Project	IEEE 802.16 Broadband Wireless Access Working Group < http://ieee802.org/16 >	
Title	FAST_FEEDBACK Channel Codeword Extension	
Date Submitted	2004-07-08	
Source(s)	Myung-Kwang Byun, Seungjoo Maeng, Jaeho Jeon, Soonyoung Yoon, Panyuh Joo	mk.byun@samsung.com
	<p>Samsung Electronics Co., Ltd. Dong Suwon P.O.Box 105 416, Maetan-3dong, Yeongtong-gu, Suwon-city, Gyeonggi-do, Korea 442-600</p>	
Re:		
Abstract	FAST_FEEDBACK Channel Codeword Extension	
Purpose	Adopting of proposed method into P802.16e	
Notice	This document has been prepared to assist IEEE 802.16. It is offered as a basis for discussion and is not binding on the contributing individual(s) or organization(s). The material in this document is subject to change in form and content after further study. The contributor(s) reserve(s) the right to add, amend or withdraw material contained herein.	
Release	The contributor grants a free, irrevocable license to the IEEE to incorporate material contained in this contribution, and any modifications thereof, in the creation of an IEEE Standards publication; to copyright in the IEEE's name any IEEE Standards publication even though it may include portions of this contribution; and

Figure bb1—Subcarrier Mapping of FAST_FEEDBACK Modulation Symbols for PUSC

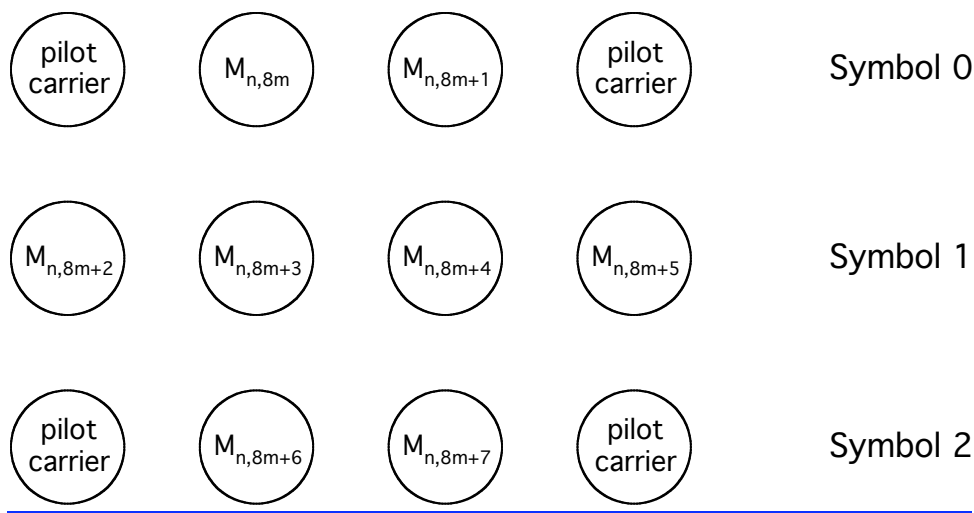
$M_{n,8m+k}$ is mapped to FAST_FEEDBACK channel tile as shown in Figure bb1 for PUSC uplink subchannel and in Figure bb2 for optional PUSC uplink subchannel. A FAST_FEEDBACK channel is mapped to one subchannel composed of 6 tiles.

Figure cc—Mapping of MIMO coefficients for fast MIMO feedback payload bits

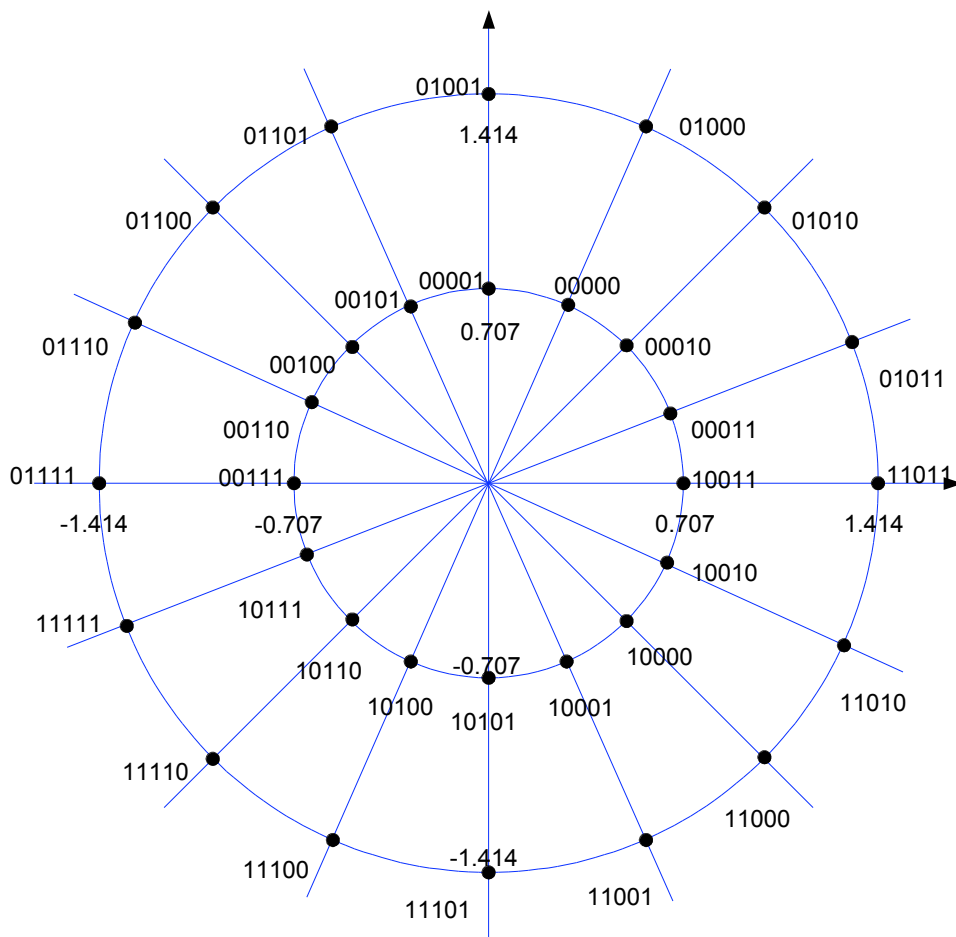
When the FAST_FEEDBACK subheader Feedback Type field is ‘01’ or ‘10’ the SS shall report the MIMO coefficient the BS should use for best DL reception (see 8.4.8.1.6). The mapping for the complex weights is shown in Figure cc.

Figure bb1—Subcarrier Mapping of FAST_FEEDBACK Modulation Symbols for PUSC

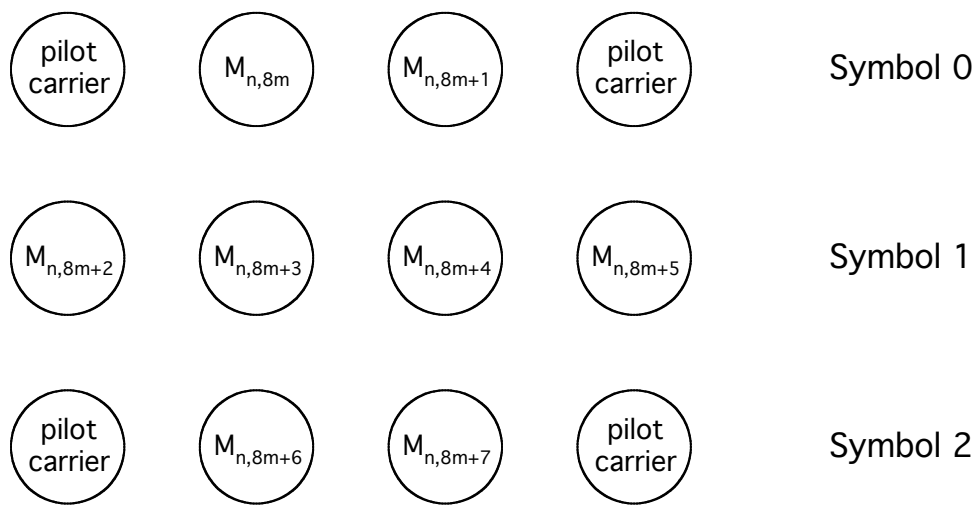
$M_{n,8m+k}$ is mapped to FAST_FEEDBACK channel tile as shown in Figure bb1 for PUSC uplink subchannel and in Figure bb2 for optional PUSC uplink subchannel. A FAST_FEEDBACK channel is mapped to one subchannel composed of 6 tiles.

Figure cc—Mapping of MIMO coefficients for fast MIMO feedback payload bits

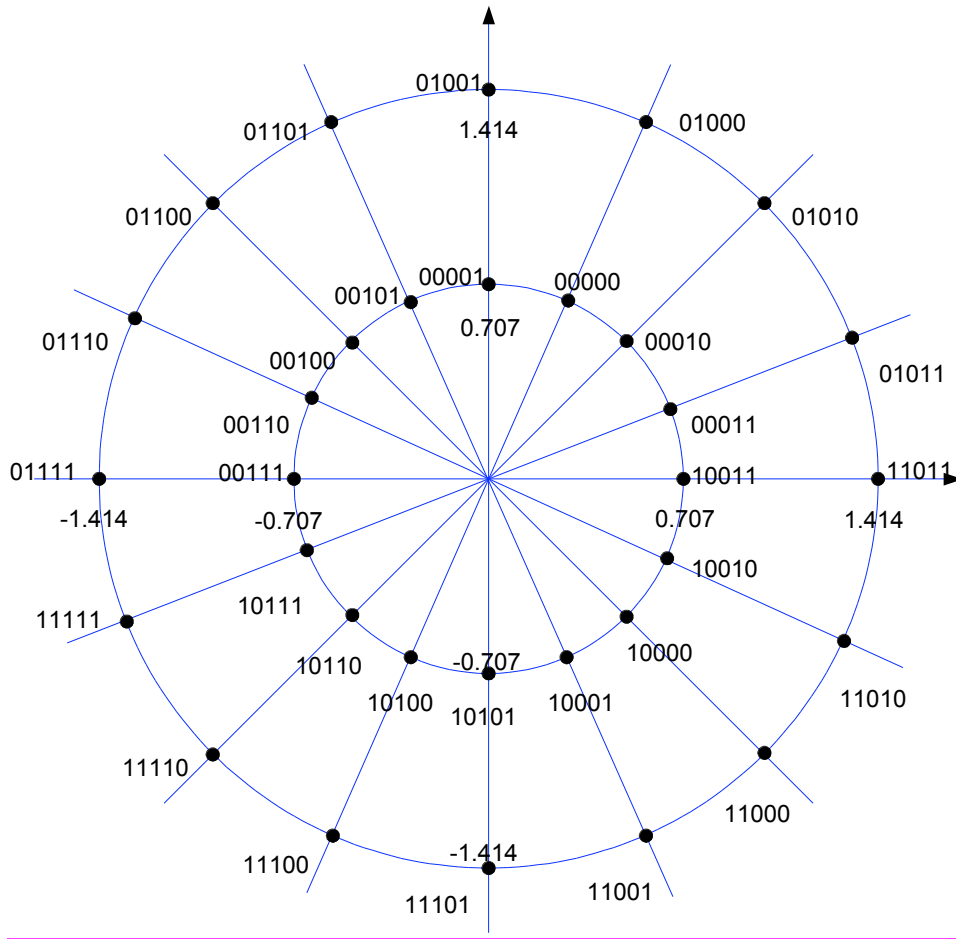
When the FAST_FEEDBACK subheader Feedback Type field is ‘01’ or ‘10’ the SS shall report the MIMO coefficient the BS should use for best DL reception (see 8.4.8.1.6) or send its selection in terms of MIMO mode (STTD versus SM) or permutation mode on the assigned FAST_FEEDBACK channel. For the first 32 codewords, the mapping for the complex weights is shown in Figure cc.
